STAFF RECOMMENDATION
3649 Richland Avenue
Lot 3, Richland Hall Development
May 18, 2016

Application: New construction—infill and outbuilding; Setback determination
District: Richland-West End Neighborhood Conservation Zoning Overlay
Council District: 24
Map and Parcel Number: 10409028200
Applicant: Chad Gore, Mike Ford Builders
Project Lead: Melissa Baldock, melissa.baldock@nashville.gov

Description of Project: Application is to construct a new single family infill and an outbuilding. Both the infill and the outbuilding are to be located three feet (3') from the interior property line. Since base zoning requires a five foot (5') side setback for both structures, the project requires a setback determination

GARAGE ELEVATIONS

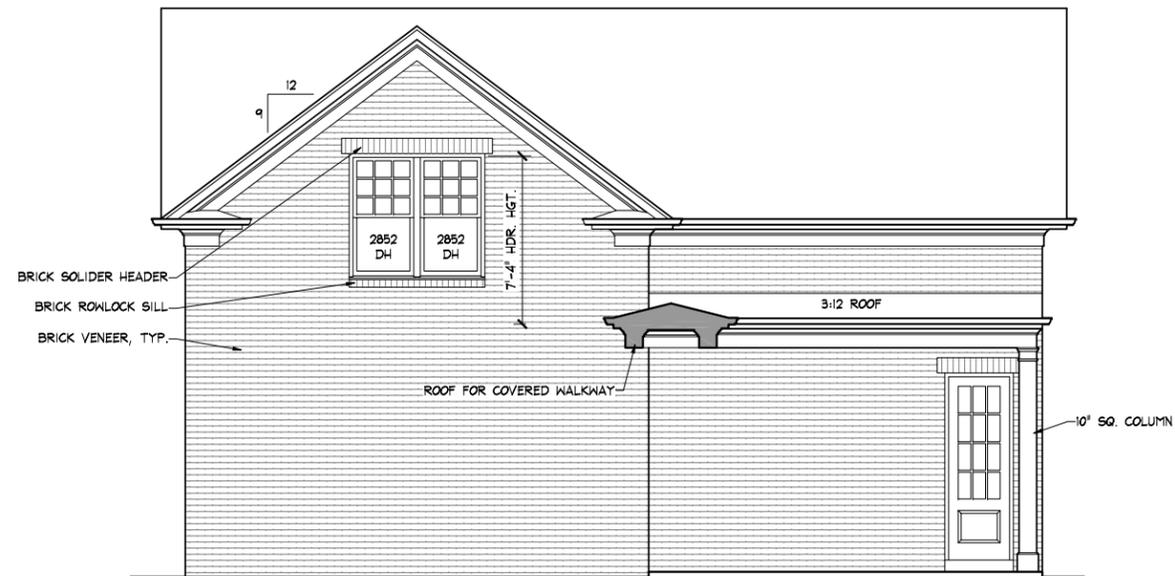
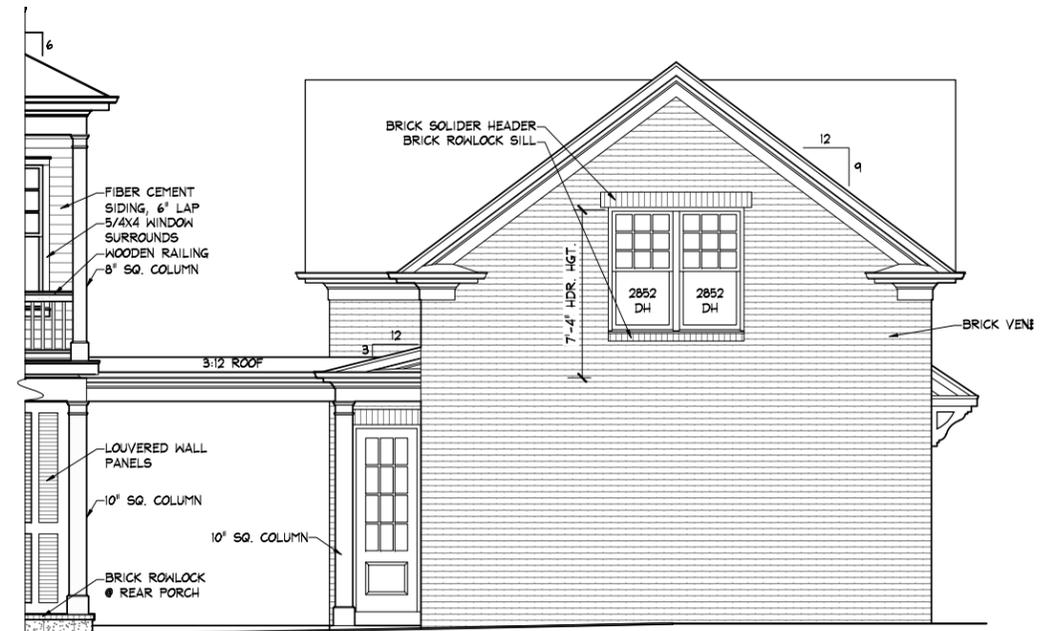
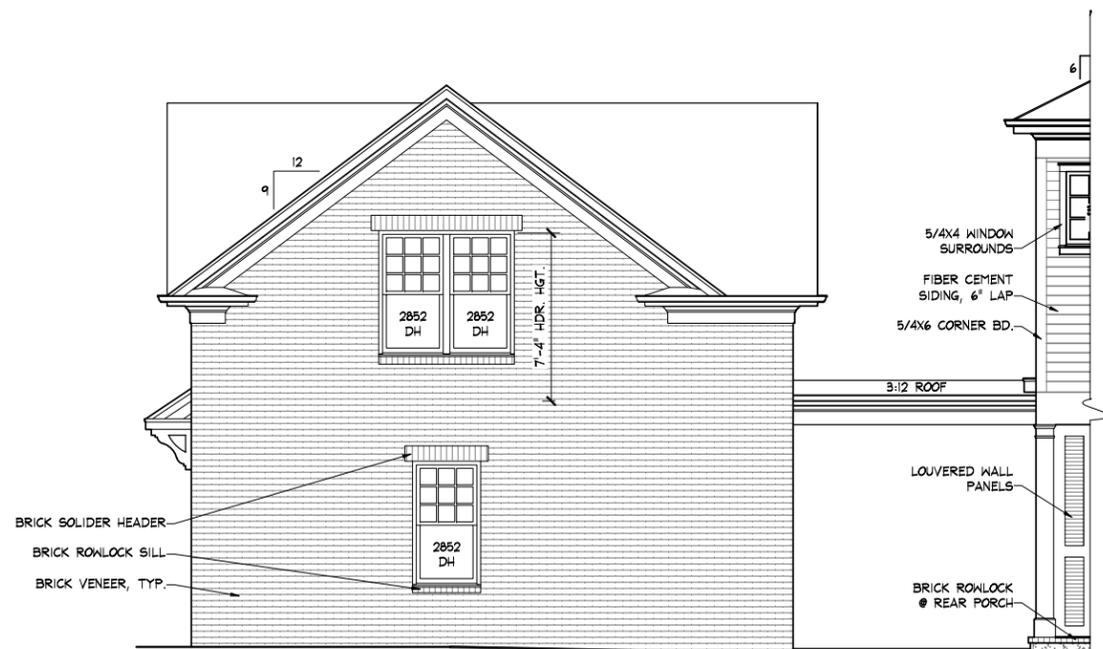
Outbuildings: See the attached Outbuilding Worksheet for a full analysis of how the proposed outbuilding meets the design guidelines. The outbuilding is not approved as a Detached Accessory Dwelling Unit, as the neighborhood is zoned for single family use. The outbuilding's footprint is approximately eight hundred and ninety square feet (890 sq. ft.), which is appropriate since the lot is over ten thousand square feet (10,000 sq. ft.). The outbuilding will be accessed via a new private alley at the rear of the property. The garage doors will face the rear of the lot.

Base zoning requires that outbuildings larger than seven hundred square feet (700 sq. ft.) be located twenty feet (20') from the rear property line and five feet (5') from the side property lines. The outbuilding will be approximately forty-six feet (46') from the rear property line, although it will appear to be much closer because it is twenty feet (20') from the new alley created on the rear of the property. The outbuilding will meet the right side setback, but will require a side setback determination left side property line. It will be just three feet (3') from the left side property line rather than the required five feet (5'). Staff finds the proposed three foot (3') side setback to be appropriate because it will line up with the setback of the proposed infill. In addition, historically, outbuildings were located close to or on the side property lines. There will be approximately ten feet (10') in between the infill and the outbuilding. The outbuilding and the primary building will be connected via covered walkway that is open on both sides and less than four feet (4') wide.

The known materials for the outbuilding have all been approved by the Commission in the past and include brick to grade, asphalt shingle primary roof, and metal awnings over the pedestrian and vehicular doorways. Staff recommends approval of a brick sample, the roof color, and all windows and doors prior to purchase and installation. With the final approval of all materials, staff finds that the proposed outbuilding meets Section II.B.1.h of the design guidelines.
